**Re: 144 Fore Street : Change of Use to Professional Offices (for VA Medical Office),
Building Renovation and Minor Site Plan
Applicant: Jackrabbit, LLC
Application # (HTE) 10-79900012**

RE: 144 Fore Street: Change of Use to Professional Offices (for VA Medical Office),
Building Renovation and Minor Site Plan Application

Re: 144 Fore Street Building Renovation and Minor Site Plan
Portland, Maine
Application # (HTE) 10-79900012

CP401 DETAIL PLAN (dated 9-1-10 IFC)

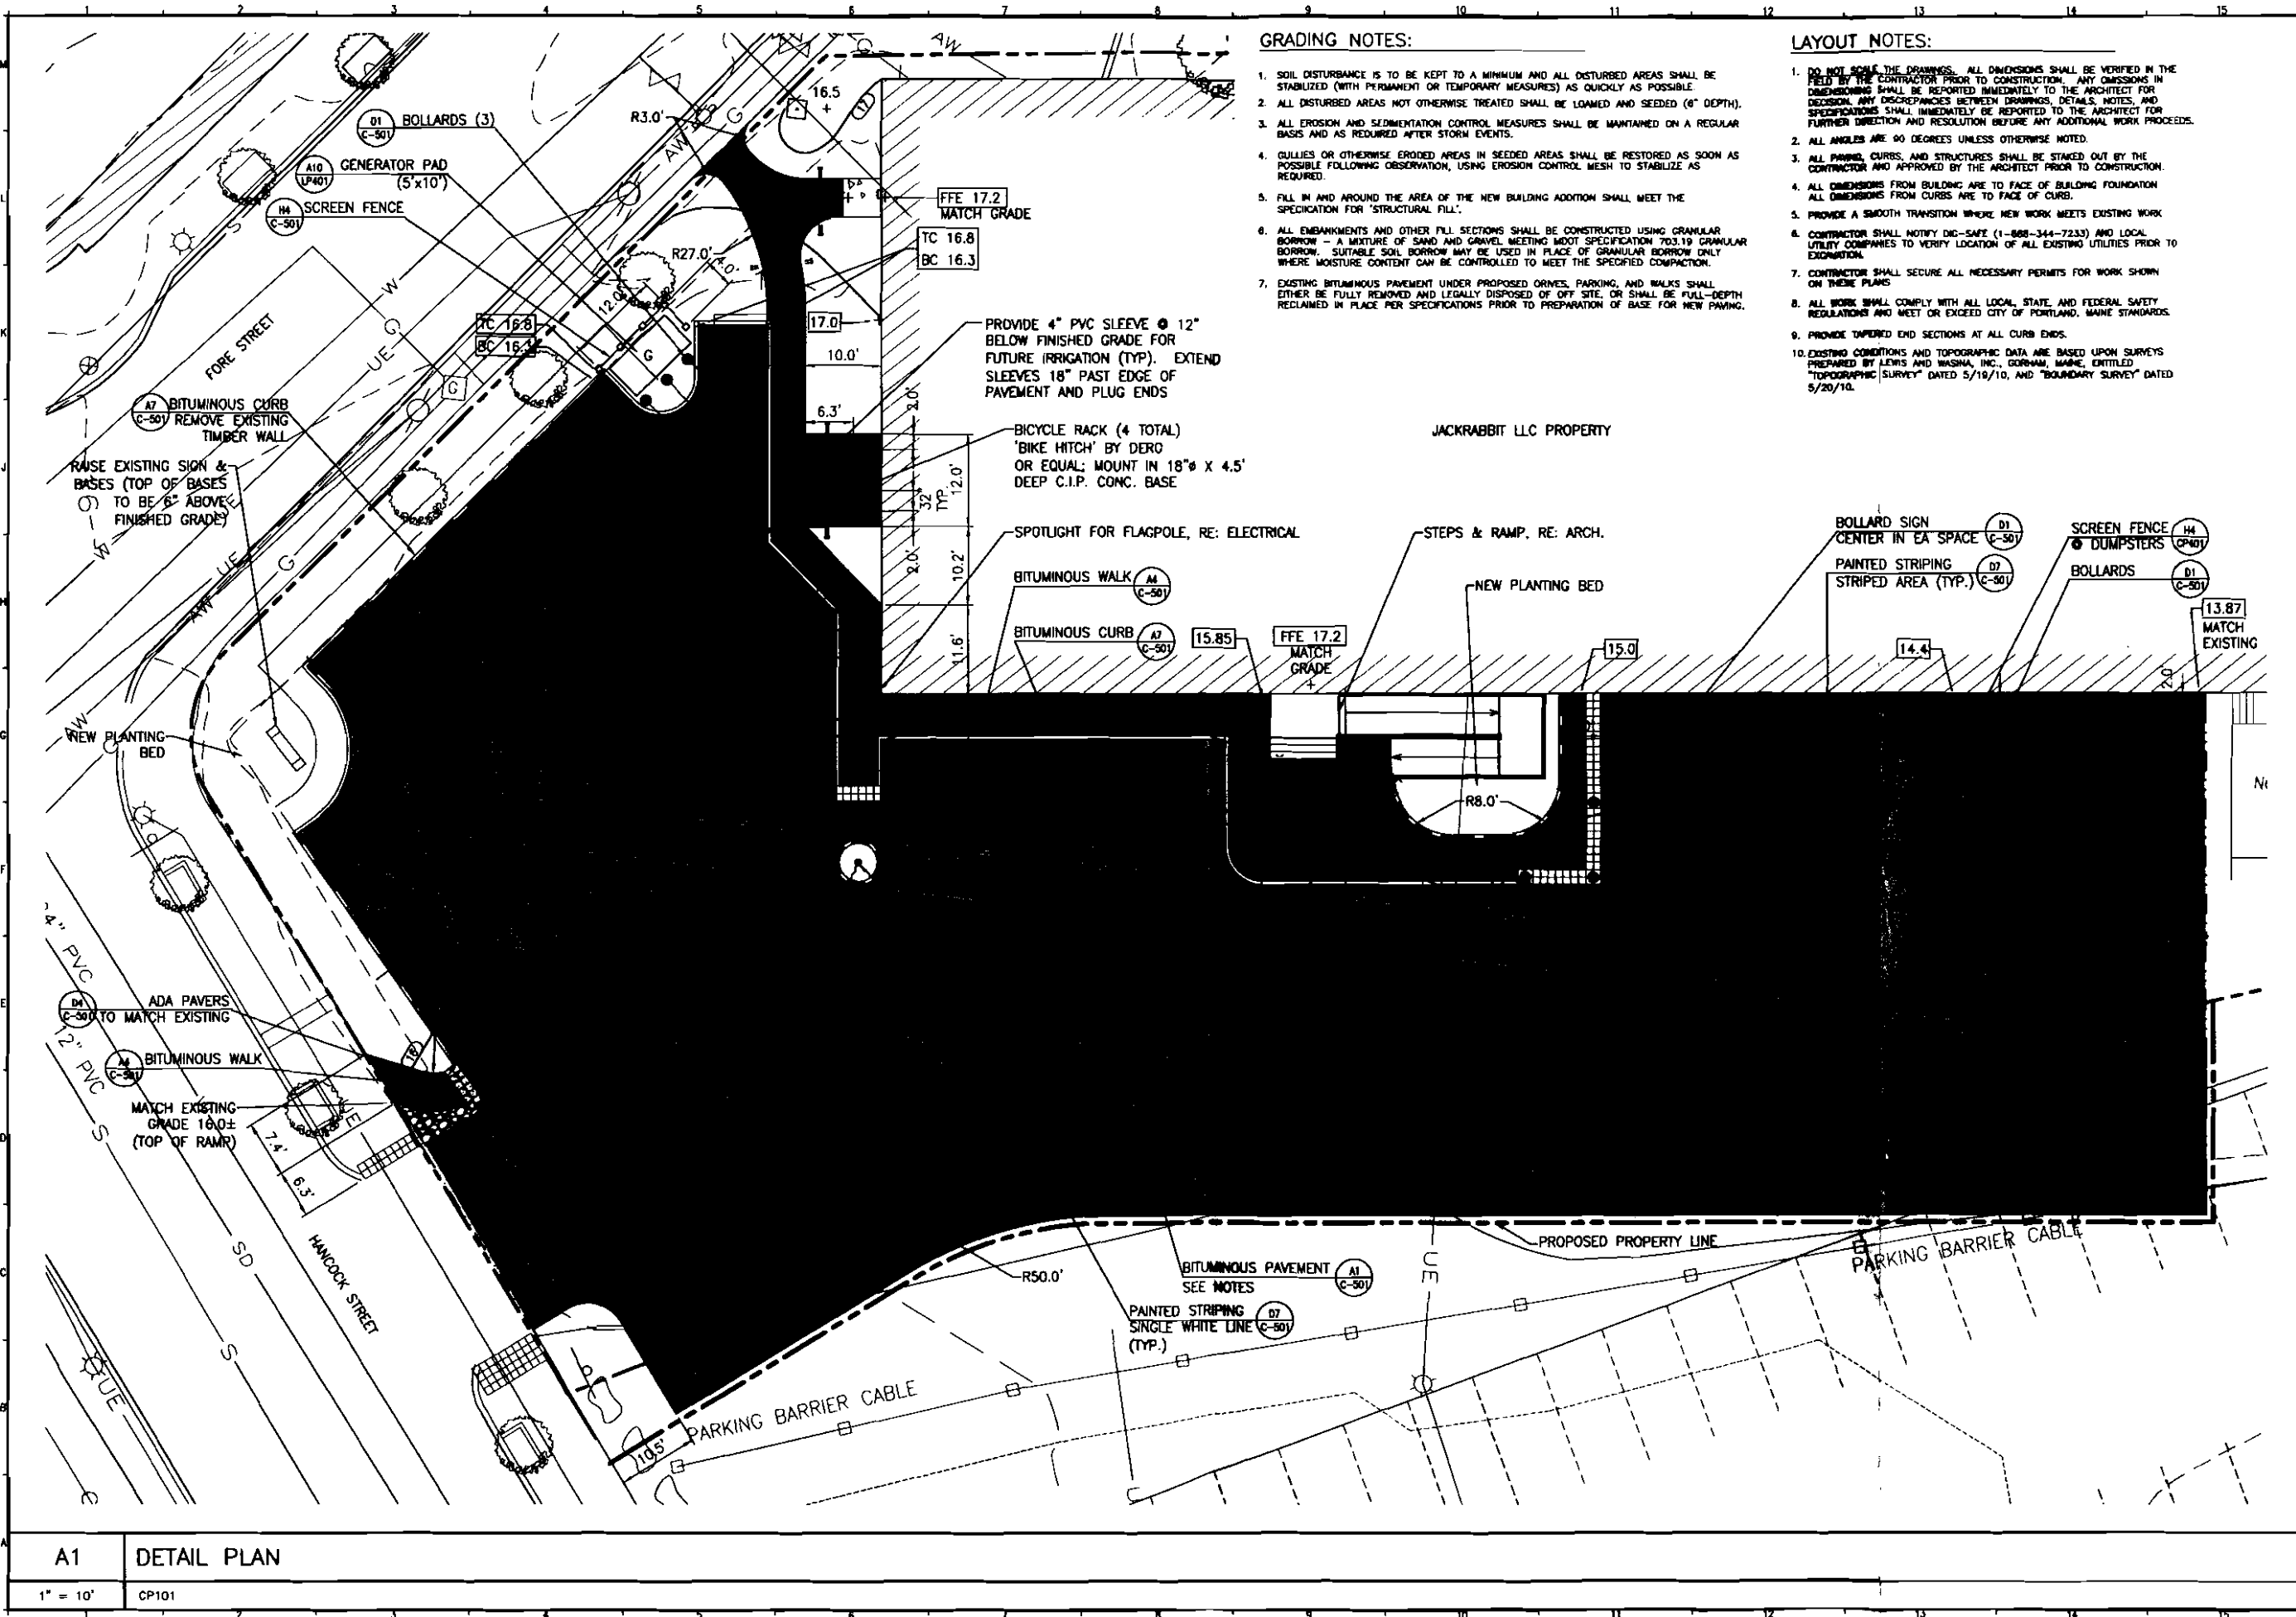
- i. *That the 40 parking spaces that serve the medical offices shall be located near the building entrance, west of the dumpster storage area and adjacent to Fore Street/Hancock Street.* **Response: The 40 spaces are located as requested. Please refer to attached plan CP401 DETAIL PLAN.**

- ii. *That the crosswalk from Hancock Street into the site shown on Site Plan CP101 (dated 8.13.2010) shall be revised, for review and approval by the Planning Authority prior to the issuance of a building permit, to avoid crossing the main drive entrance from Hancock Street. One of the two pedestrian links between the building and adjacent streets (Fore Street and Hancock Street) shall be ADA compliant.* **Response: Both pedestrian access links are now ADA compliant as a result of site grading modifications incorporated into the design. Please refer to attached plan CP401 DETAIL PLAN.**

- ix. *That the applicant is advised that there is existing ponding in the parking area and regrading (when resurfacing) to address this problem is advisable. Response: So noted. Please refer to the attached plan CP401 DETAIL PLAN for revised grading as described above.*
